### **ADDENDUM #2**

#### **Bid 102-22 Athletics Stadiums Project**

#### **Palomar Community College District**

# EXHIBIT "B"

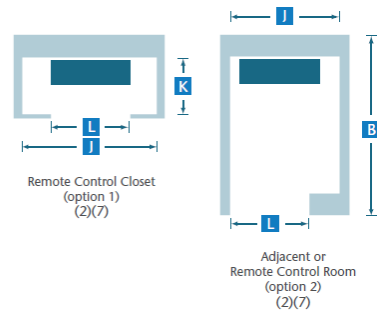
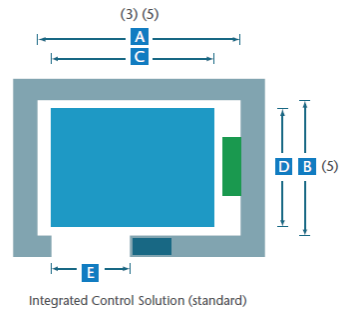
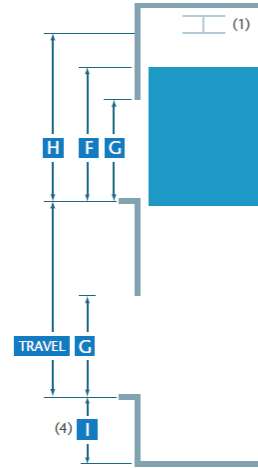
Please see attached (*Exhibit A & B*) and below a request to substitute the elevator per the specifications with the Kone Monospace 300.

KONE will be happy to provide an alternate MRL (machine room-less) traction elevator, in lieu of the hydraulic elevator specified.

Attached please find the catalog for the KONE MonoSpace 300 product. The advantages of the MRL vs. hydraulic include the following:

- 1.) up to 70% more efficient
- 2.) No requirement for equipment room on first landing next to the elevator shaft, the CA state required control room can be located anywhere in the building, creating more usable space for the building.
- 3.) smaller electrical switch gear and wiring reducing construction costs.
- 4.) no requirements for sprinklers in the hoistway, reducing construction costs.
- 5.) lower life cycle costs over the life of the elevator for reduced maintenance visits and costs
- 6.) No hydraulic fluid in the building, eliminating the smell and environmental impacts of the hydraulic fluid.
- 7.) Smoother ride
- 8.) specified 3500 Lb capacity will fit in hoistway as shown on plans

***RESPONSE:** This substitution request is rejected as it is not submitted with the necessary back up documentation as outlined in 01 60 00 Section 1.06B (including the necessary side-by-side comparison). A revised substitution request may be re-submitted with the required information on the form included in this Addendum #2 (See response to Request for Information Questions #4).*

## EXHIBIT "C"

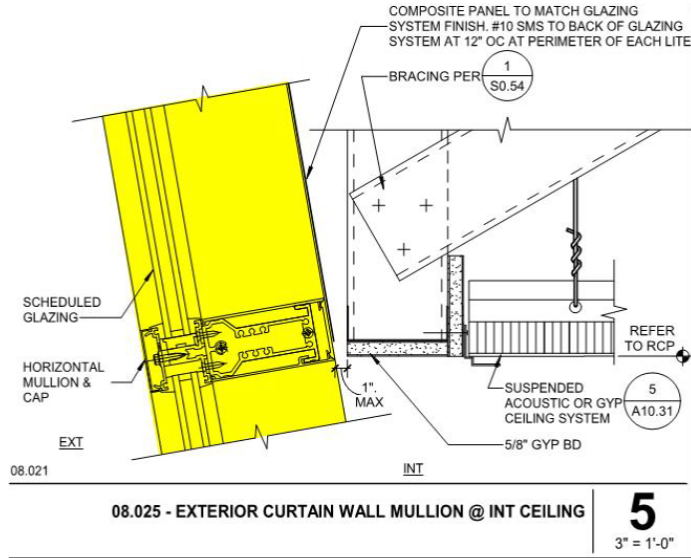
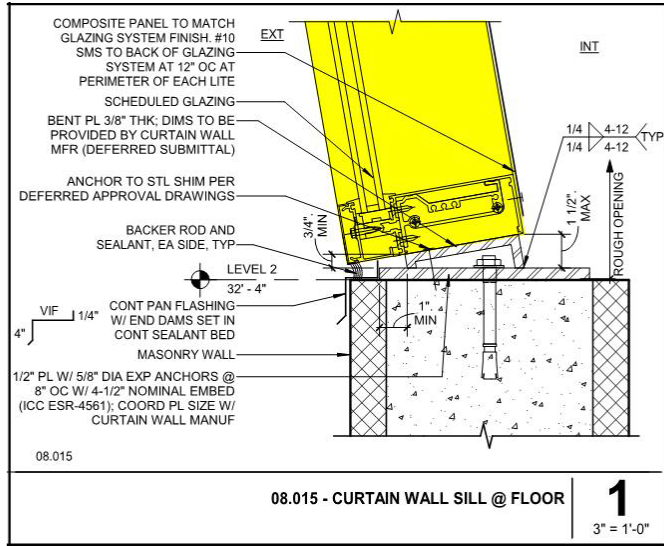
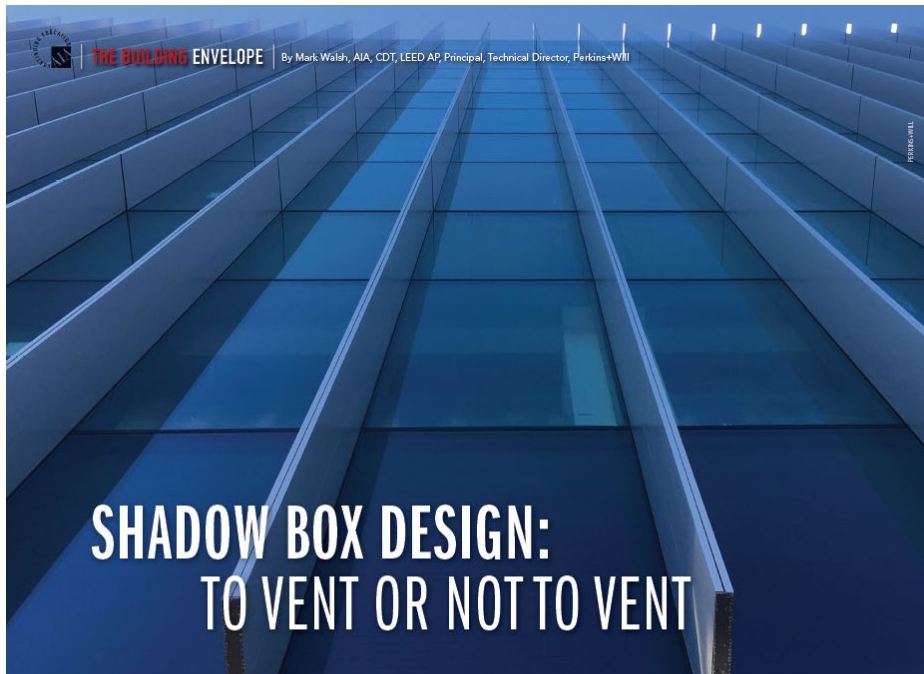
- (5) QUESTION: Regarding Spec section 08 80 00-05 2.02 A 'Glass Materials'; Is GL-2 Spandrel glazing or Vision glazing? (Foil faced rigid insulation will be visible, if vision glass).

- (6) QUESTION: Regarding Spec section 08 80 00-05 2.02 A 'Glass Materials'; Will a drain cavity be required at GL-2? If yes, please provide detail for bidding subs to follow.

- (7) QUESTION: Regarding Spec section 08 80 00-05 2.02 A 'Glass Materials'; if a drain cavity is required at GL-2, will the GL-2 portion of the curtainwall be included in the air & water site testing?

- (8) QUESTION: Regarding Spec section 08 80 00-05 2.02 A 'Glass Materials'; if a drain cavity is required at GL-2, have the drain cavities been factored into testing requirement performance levels?

- (9) QUESTION: Regarding Spec section 08 80 00-05 2.02 A 'Glass Materials'; are the shadow box referenced in GL-2 & Composite panel referenced in the curtainwall detail on A10.22 different items?

- (10) QUESTION: Please confirm the rigid insulation is to go between the glass & shadow box? Curtainwall details on A10.22 show composite panels fastened to int surface of curtainwall. Rigid "foil faced insulation would be visible through vision glass, if between glass & shadowbox.

*RESPONSE: GL-2 is a vision glazed panel with a shadow box behind. The rigid insulation required in the specifications shall be adhered to the back side of the shadow box metal panel, towards the inside of the building, not visible from the exterior.*

*RESPONSE: Drain cavities are required where indicated in the specifications. The entire curtainwall system, regardless of glazing type shall be tested per Specification*

*Section 08 44 14. Drain cavities, where required shall be part of the Curtainwall deferred approval shop drawings.*

*RESPONSE: The entire curtainwall system shall be tested per Specification Section 08 44 14.*

*RESPONSE: The entire curtainwall system shall be tested per Specification Section 08 44 14.*

*RESPONSE: Correct. The "Composite panel" referenced in all Curtainwall Details shall be interpreted to mean the "Shadow box" as outlined in GL-2.*

*RESPONSE: The rigid insulation is to be installed on the back side of the shadowbox between the metal face and the interior of the building, therefore not visible from the exterior.*
